WRITTEN RESPONSE TO THE EIS (Appendix E - Biodiversity development assessment report)

Figure 8-1. Vegetation impacted by the Project

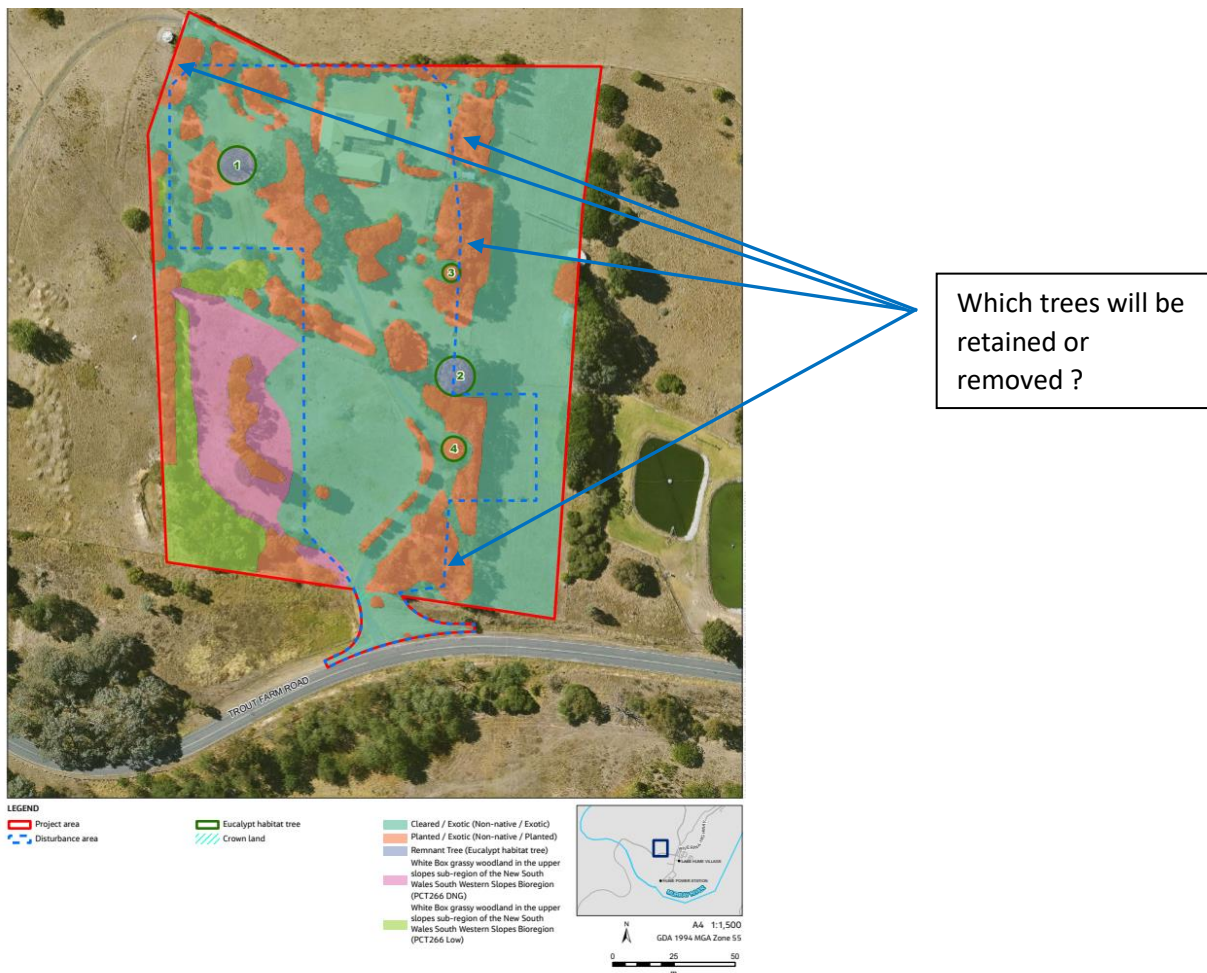
3. It is unclear which trees will be removed or retained. In Figure 8-1 (Vegetation impacted by the Project) there is little detail or clarification on the impact on trees that straddle the blue dotted line that delineates the extent of impact (see figure below). Does the “area of disturbance” include trees outside the earthworks but still impacted as works may occur within their dripline. Given a considerable amount of vegetation occurs along this extent line, a more detailed tree set out is necessary to identify trees that will be retained or removed. The **Planning Secretary’s Environmental Assessment Requirements** states that there should be a ‘*high quality site plan at an adequate scale.*’ At this detail we can see little in terms of the design’s intent in regard to tree protection.
